CABINET MEMBER FOR ENVIRONMENT – 11 JANUARY 2018
HARWELL LINK ROAD AND B4493 WANTAGE ROAD DIDCOT /
HARWELL – PROPOSED 50MPH AND 30MPH SPEED LIMITS

Report by Director for Infrastructure Delivery

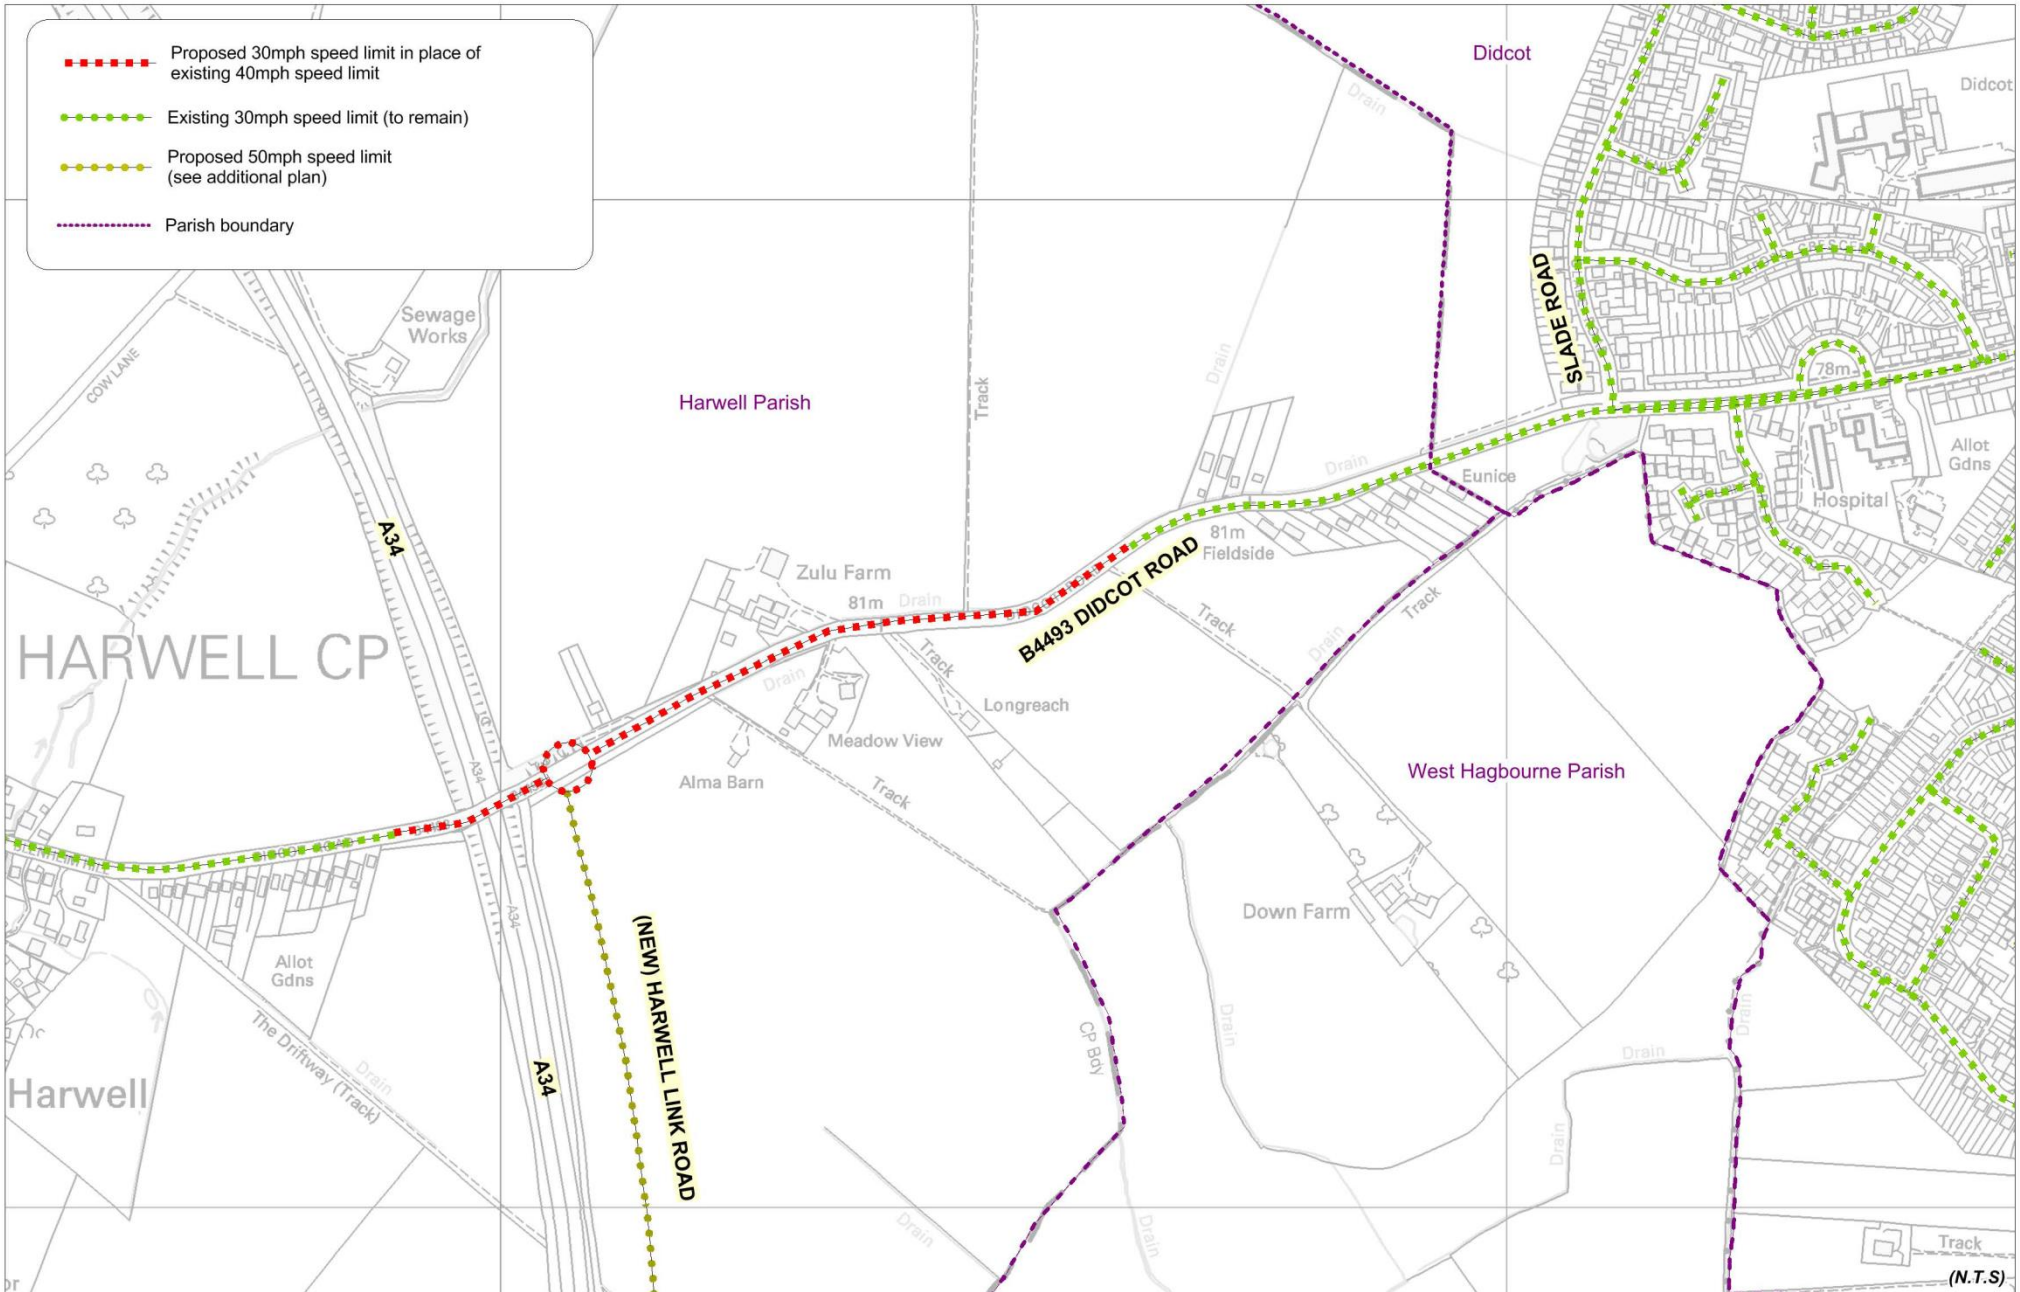
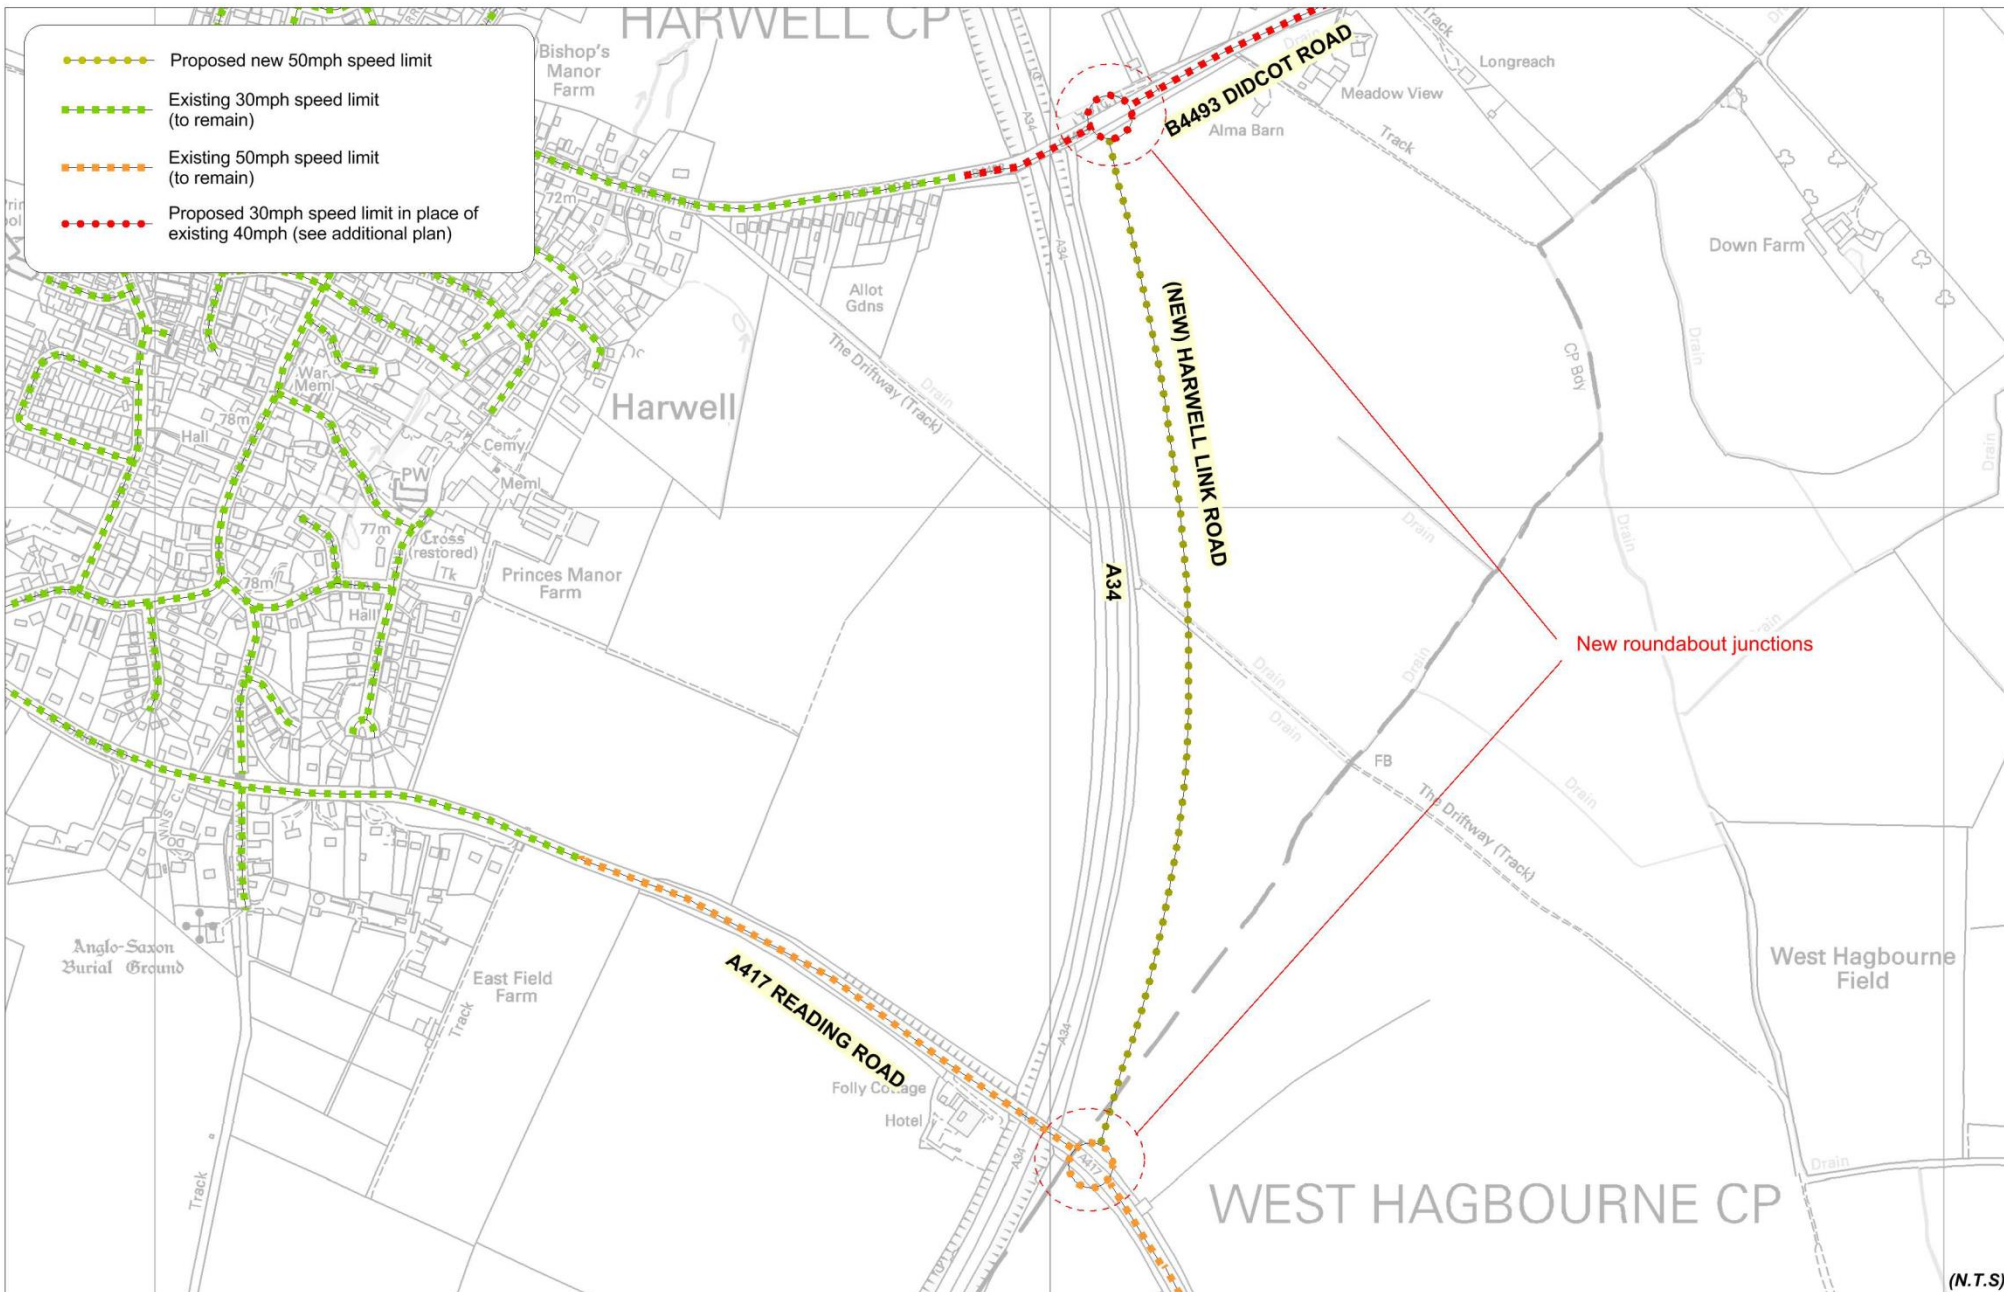
5. Thames Valley Police expressed no objection to either proposal but did request that speed data should be obtained following the opening of the link road. Didcot Town Council, while expressing no objection, did nevertheless question why a 50mph speed limit was required on the link road, give their expectation that the design of the new road should provide for the speed limit to be set at the National Speed Limit (60mph).

8. The three objections from members of the public in respect of the 50mph included concerns that it would encourage speeding along the adjacent 30mph roads and, therefore, that a 40mph speed limit would be preferable; traffic problems are only observed during rush hour when it would in any case be difficult for traffic to travel at 50mph and that it was a waste of money, with it being preferable that resources would be better allocated to police enforcement to address bad driving that posed a risk to cyclists. One member of the public expressing support for the 50mph speed limit nevertheless commented that it would be preferable for this to commence approximately 100 metres south of the Harwell – Didcot road, to help ensure that speeds were reduced for the benefit of pedestrians cursing in the vicinity of the roundabout.

RESPONDENT	SUMMARISED COMMENTS
(1) Didcot Town Council	<p><u>Proposed 50mph</u> – Neither - As a new road, Didcot Town Council does not see a need for the speed limit to be set below 60mph.</p> <p><u>Proposed 30mph</u> – No objection – Although Didcot Town Council wishes to raise a wider concern about Oxfordshire County Council’s priorities regarding road safety. It would prefer that the County Council not pursue ad hoc reductions in speed limits and instead agree to implement necessary road safety measures outside of Didcot’s schools.</p>

(3) Local Resident, (The Cleave, Harwell)	<p><u>Proposed 50mph</u> - Support – The northernmost 100 metres of the link road should be part of the 30mph limit for the B4493, rather than having the limit change to 30mph at the roundabout itself. This would help pedestrians who will need to cross the link road at the roundabout when using the footpath along the B4493 to/from Harwell.</p> <p><u>Proposed 30mph</u> - Support – (Same as above)</p>

(4) Online response, (unknown)	<p><u>Proposed 50mph</u> - Neither – <i>No comment.</i></p> <p><u>Proposed 30mph</u> - Neither – <i>No comment.</i></p>
(5) Local Resident, (Barrow Lane, Harwell)	<p><u>Proposed 50mph</u> - Object – Having a 50mph limit on this section of road, directly adjacent to the 30 limit on the Didcot-Harwell Road will simply encourage speeding along the other sections. This also applies to the exit into the new</p>

<p>development at Valley Park from the link road; expecting traffic to jump from 50mph to 30mph with no other modifications to the 30mph section is fantasy land. 40mph would be a far more sensible limit for the link road.</p> <p><u>Proposed 30mph</u> - Support – Please look at narrowing the road along this section to better fit the reduced speed limit and allow for natural enforcement. This could be achieved via some nice wide segregated cycle tracks.</p>

7. The response from Thames Valley Police is noted, and it is confirmed that a speed survey will be carried out on the link road following its opening. In respect of Didcot Town Council's comment that the new link road should have been designed to accommodate the national speed limit, land and other constraints relating to the alignment of the new road did not make this feasible.

9. In respect of the above objections and comments, it is considered that the proposed 50mph speed limit is appropriate taking account of the alignment of the new link road and similarly that the terminal point just south of the new roundabout junction with the Harwell-Didcot road is consistent with normal practice.
